Duke responses to CCEBA's Response to CTPC on MSVT ERIS Scenario – December 3, 2024

Table 1: 2034 hourly simulation for P3 Portfolio

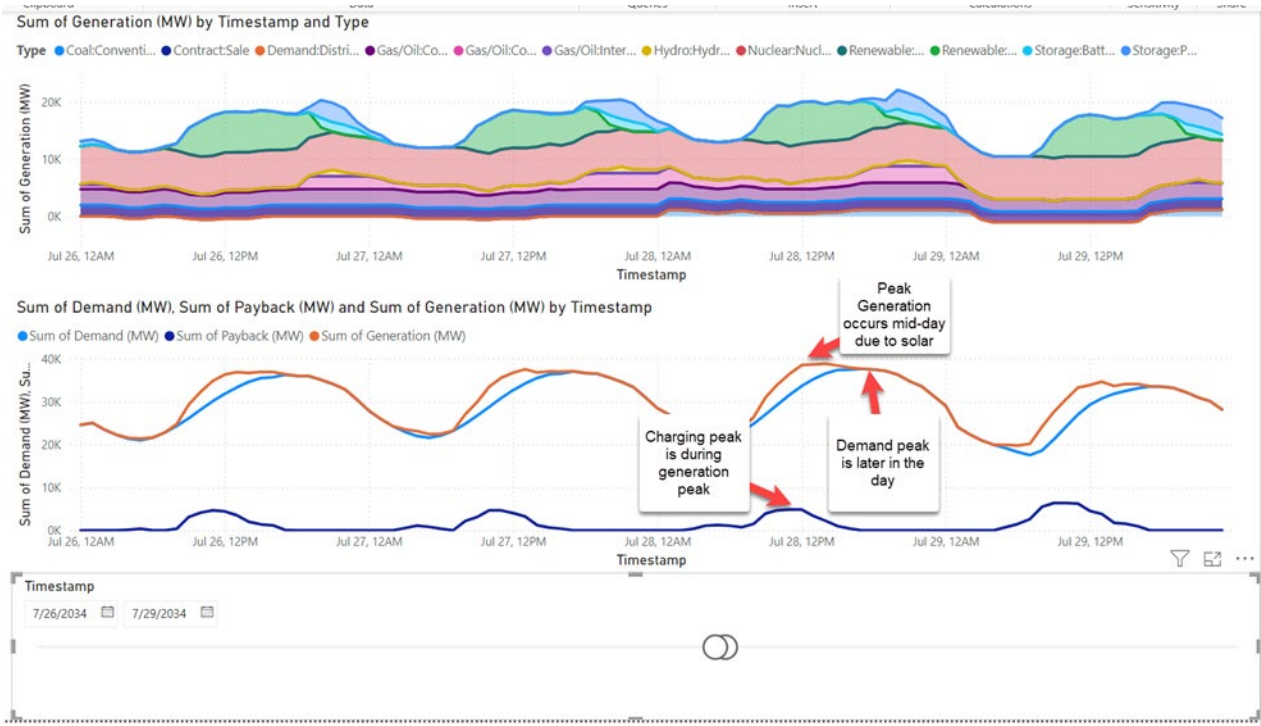
Furthermore, for summer periods, Duke's analysis performed as part of the 2023 CIPRP shows that as more solar and storage resources are added to the system, Duke will need to be able to charge storage through HE13:00 in the summer (i.e. when AAR/DLR produced facility ratings for transmission lines are lowest) and be able to discharge storage over the net demand peak later in

the day. Therefore, CCEBA is incorrect that grid-scale storage systems are unlikely to be charged during congested on-peak periods.

Load Demand at noon during peak charging is 89% of the summer peak at 5 PM.
